Crown Pastoral Land Tenure Review

Lease name: LAKE HAWEA

Public Submissions - Part 2

Tenure Review - Part Run 263 and 263A - LAKE HAWEA - Preliminary Proposal

Photos 1 and 2 True right of Johns Creek near Saddle

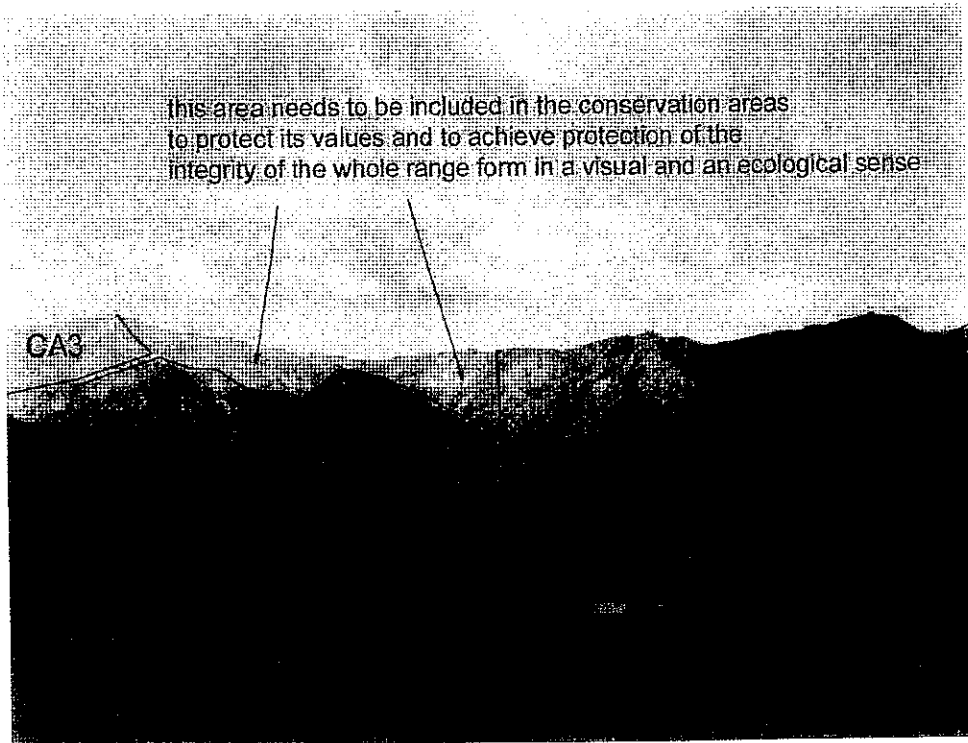
We do have some concern however with regard to the southern end of this block - the darker lying country to the west of Johns Creek Saddle (see map, photos 1 and 2). We cannot see that it can be ecologically sustainable to farm this land. It is very steep and rugged, with much rock outcrop. It has a cool southerly aspect and is of altitude 800m - 1300m asl. It is Class VII e land. Snow tussock grassland, rock scree and sub-alpine shrubs are its dominant vegetation cover providing little grazing value.

The area in the left photo, and the area above the black line in the right photo (taken further downstream) should be retained in Crown ownership as conservation land (for location of these areas please see Map). This is steep, rugged, high altitude (800-1300m asl) Class Vlle country of southerly aspect, with a predominance of (degraded) subalpine shrubland and tall tussock, and scree, with little value for pastoral use. It has high natural landscape value - it is an important part of the mountain range backdrop to the Upper Clutha Basin and Lake Hawea - an iconic view from SH6 and Hawea township and foreshore. Addition of this area to CA1 will enable a continuous conservation area to be achieved along the range together with the proposed retention of RAP A7 as conservation land. This is an important goal to achieve. Unimpeded public walking access will also now be possible right along the ridgeline between Grandview and Breast Hill, with spectacular views out over the lake to the western mountains. This is not possible from the existing 4WD track as it is east of and below the ridge in most places with no provision for access as of right between the tracks and the conservation areas.

The upper true right of Johns Creek valley should be conservation area, with a new fence as shown. A farm access easement will need to be provided. Thus CA3 will be connected to CA1.

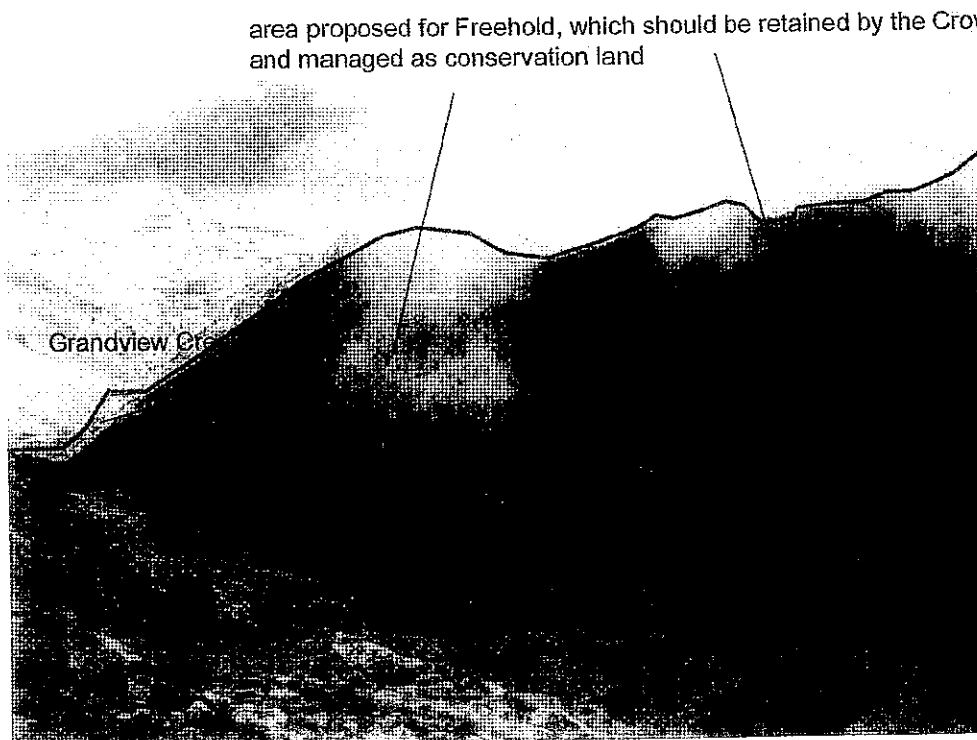
The basin at the head of Grand View Creek, RAP A7, is very steep and rocky (see Photo 3 and 4). It too is Class VII e land and of southerly aspect, and altitude range from 600-1300m or more. Like Johns Creek in point 1, we cannot see it being ecologically sustainable to continue to farm this as it will not be economically viable. To satisfy the objectives of the CPLA, it needs be part of the conservation area CA5.

The area should reach the end of the marginal strip in Grandview Creek, to enable public access up the creek and into the conservation area. At present the marginal strip is shown as terminating just short of the CA5 area. Fence AB can be re-located along the northwest rim of the basin (See map).

Include all of the upper Grandview Basin as conservation area, linking CA3 and CA5. Connect to marginal strip at downstream end. Fence along western rim.

Photo 5.

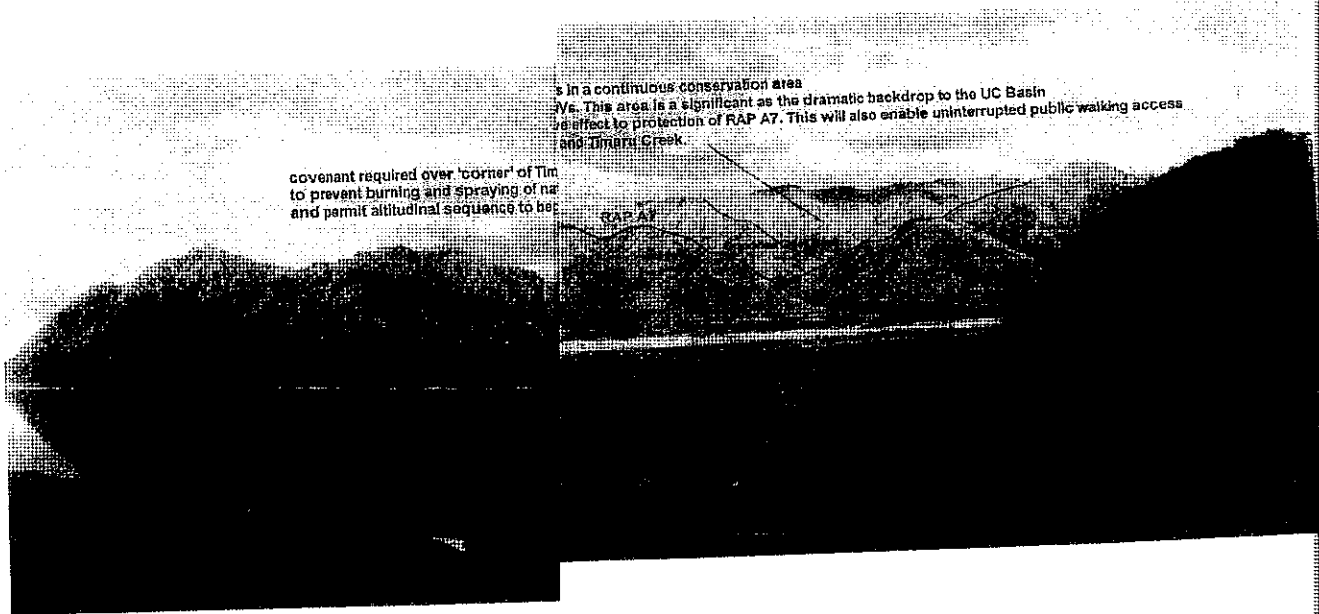
A further required action is to place a covenant over the land between the road and the lake to prevent subdivision and built development (refer Point 10, see Photo 5).

A covenant is required over this land between the road and the lake near the homestead, to prevent subdivision and built development. This would very likely destroy the valued open pastoral character which is particularly valued in the landscape between Johns Creek and Hawea township.

The district plan is not a secure 'backup' to prevent this, as the plan can be changed at any time, and already Council has permitted residential development on the land enclosing the lake, which will result in degradation of the open pastoral to natural character. The Lake Hawea Station land is particularly strategic in preventing urban sprawl - by securing a strong clean urban boundary to the settlement of Johns Creek.
